SIMATIC

S7-1200

Update to the S7-1200 System Manual, edition 09/2016

Product Information

CPU behavior in STARTUP and RUN mode

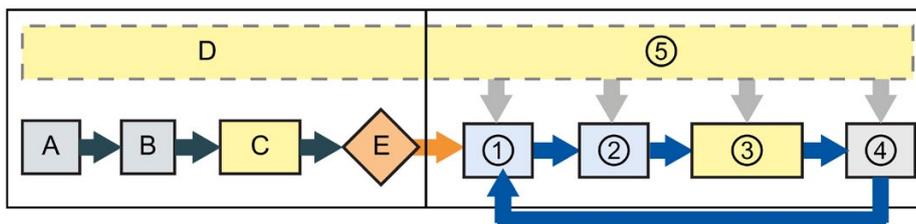
Section 5.1.1, "Operating modes of the CPU" contains incorrect information in the description of the STARTUP behavior.

In STARTUP and RUN modes, the CPU performs the tasks shown in the following figure:

- A Copies the state of the physical inputs to I memory
- B Initializes the Q output (image) memory area with either zero, the last value, or the configured substitute value. Zeroes PB, PN, and AS-i outputs
- C Initializes non-retentive M memory and data blocks to their initial value and enables configured cyclic interrupt and time of day events. Executes the startup OBs.
- D Stores any interrupt events into the queue to be processed after entering RUN mode
- E Enables the writing of Q memory to the physical outputs

- ① Writes Q memory to the physical outputs
- ② Copies the state of the physical inputs to I memory
- ③ Executes the program cycle OBs
- ④ Performs self-test diagnostics
- ⑤ Processes interrupts and communications during any part of the scan cycle

Table 10 Wiring diagram for the SM 1232 AQ 4 x 14 bit (6ES7232-4HD32-0XB0)

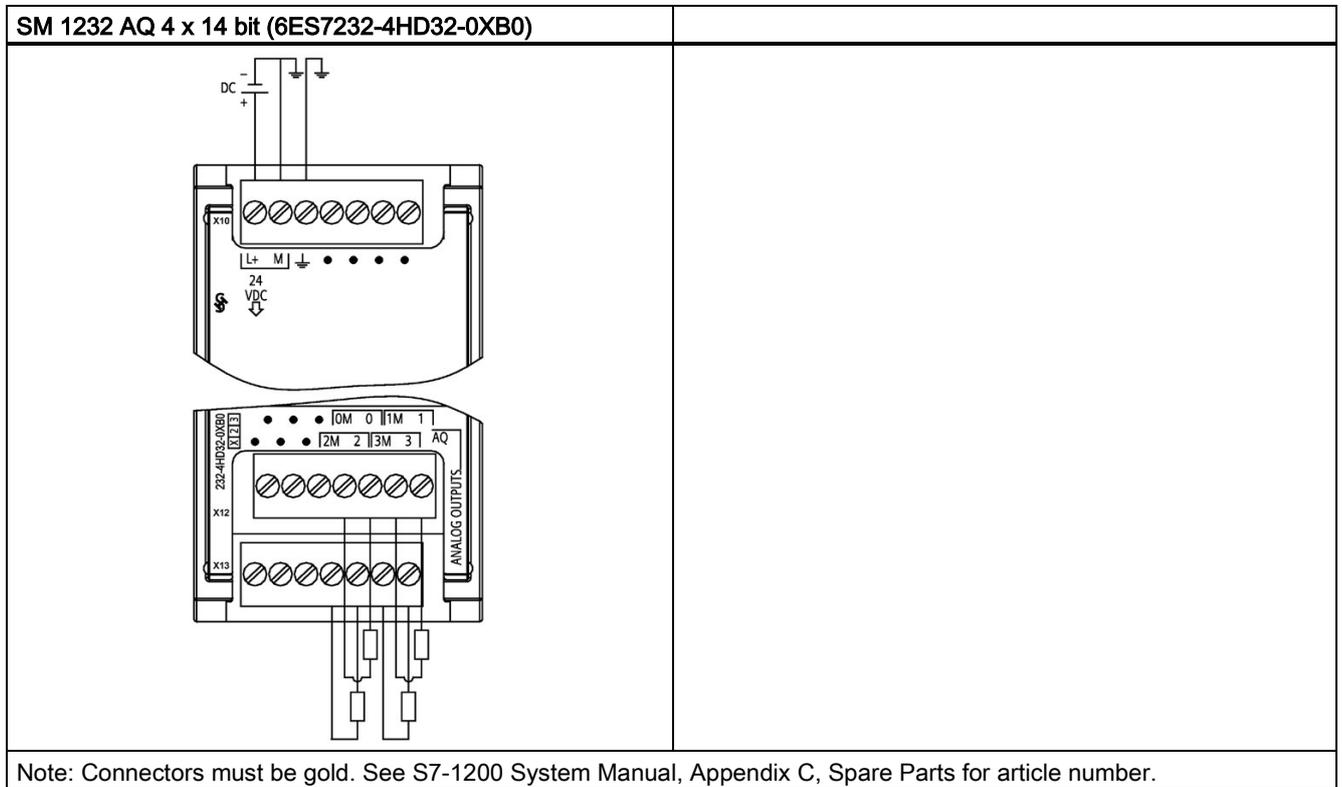
Corrections to wiring diagrams: SM 1232 and SM 1234

The wiring diagram and connector pin locations for the following analog signal modules have been corrected:

- SM 1232 AQ 4 x 14 bit (6ES7232-4HD32-0XB0)
- SM 1234 AI 1234 AI 4 x 13 bit/AQ2 x 14 bit (6ES7234-4HE32-0XB0)
